### **REMARKS**

## Drawing Objections

**Fig. 2E**

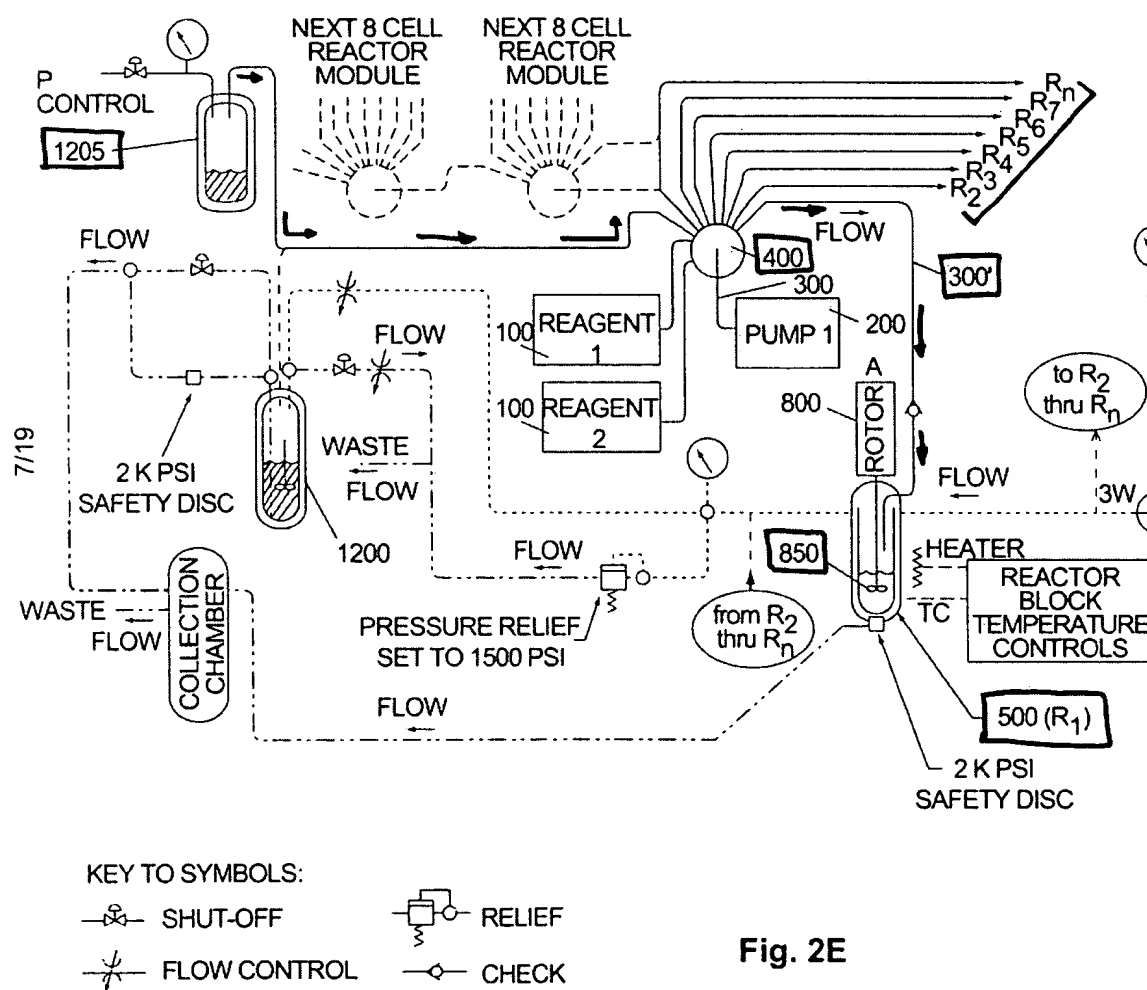
Concerning the connecting relationship between the feed-pressurization station and the reaction vessels with impellers, Applicants respectfully assert that Fig. 2E does clearly demonstrate such a relationship. In particular, Fig. 2E discloses a feed-pressurization station 1205 connected to a distribution valve 400, which is connected to several reactors, R<sub>1</sub> through R<sub>n</sub>, and in particular reaction vessel 500 (R<sub>1</sub>), via feed line 300'. Reaction vessel 500 (R<sub>1</sub>) clearly includes an impeller stirrer 850. Thus, the relationship between the feed-pressurization station and the reaction vessels with impellers is clearly shown. An annotated copy of Fig. 2E is included immediately below for your reference:

Thus, the stirred reaction vessel 500 (R<sub>1</sub>) of Fig. 2E clearly relates to the stirred reaction vessels 500 of Fig. 5A. Applicants respectfully request withdrawal of this objection. Regarding the shaft covers of claim 49, Applicants have amended Figs. 3A and 3G to include the shaft cover. In addition, Applicants have amended the specification to include reference numeral 864 corresponding to the shaft cover. According to the M.P.E.P., where an original claim constitutes a clear disclosure of subject matter, the claim may be treated on the merits and the drawings and description amended to show the subject matter.<sup>1</sup> Thus, the figure amendments and addition of the reference numeral does not add any new matter to the present application, because the shaft cover was included in original claim 49 and was described in the text of paragraphs 10, 17, and 65 of the original application. As such, Applicants respectfully request withdrawal of the objection.

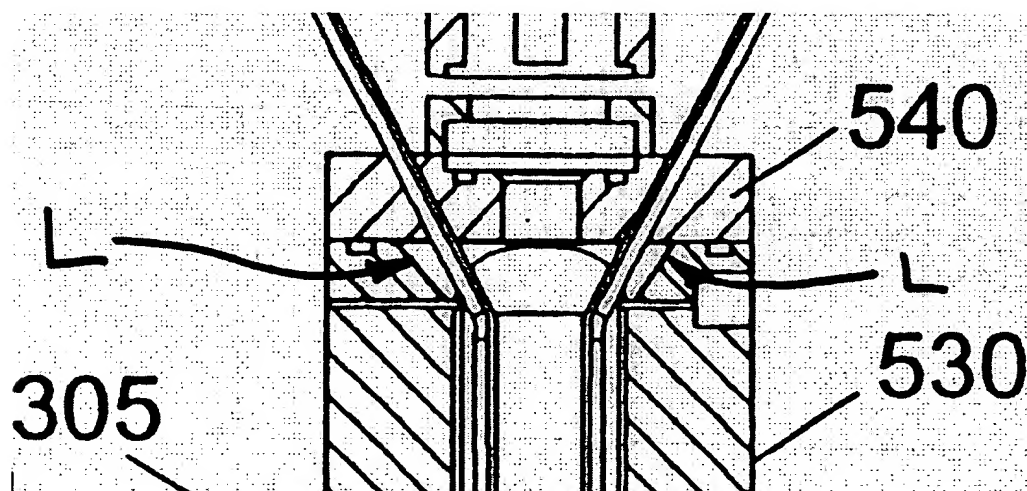
With respect to the lower portion of the reaction cavity having a substantially circular cross section and the upper portion of the reaction cavity having a substantially oval cross section, the drawings clearly show such claimed features. Concerning the circular cross section of the lower portion, Figs. 4B, 4F, and 4G show the lower portion of the reaction cavity having a substantially circular cross section. Regarding the oval cross section of the upper portion, Figs. 4B and 5A show the upper portion of the reaction cavity having a substantially oval cross section. In Fig. 4B, a cross section, the oval cross section is defined by the two sloping lines L noted in the portion of Fig. 4B reproduced below:

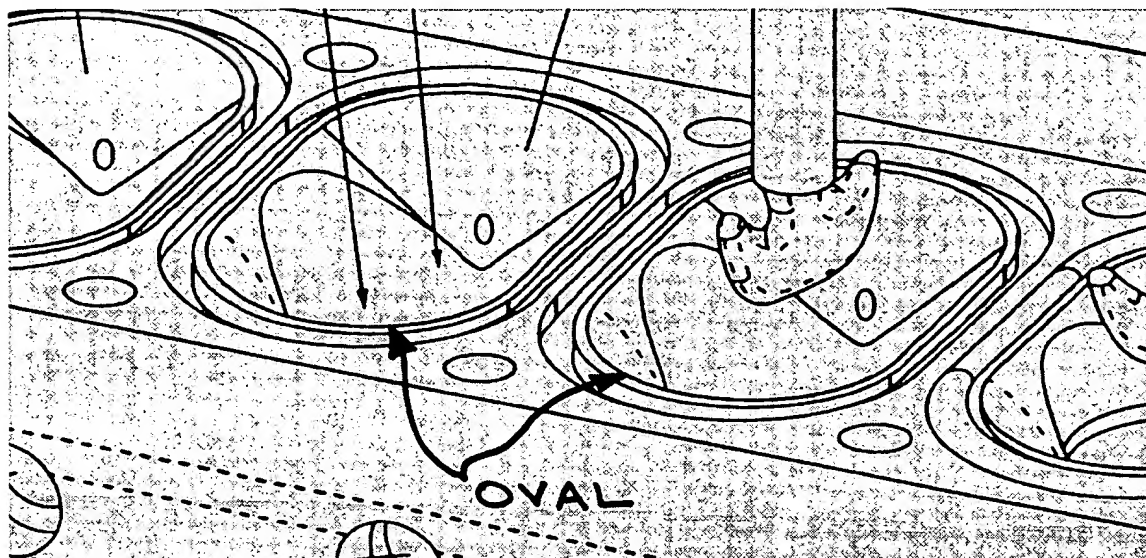
In Fig. 5A, a perspective view, the oval cross section is shown as a full oval as noted in the portion of Fig. 5A reproduced below:

Because these figures sufficiently support the claimed lower portion of the reaction cavity having a substantially circular cross section and the upper portion of the reaction cavity having a substantially oval cross section, Applicants respectfully request withdrawal of the objection.
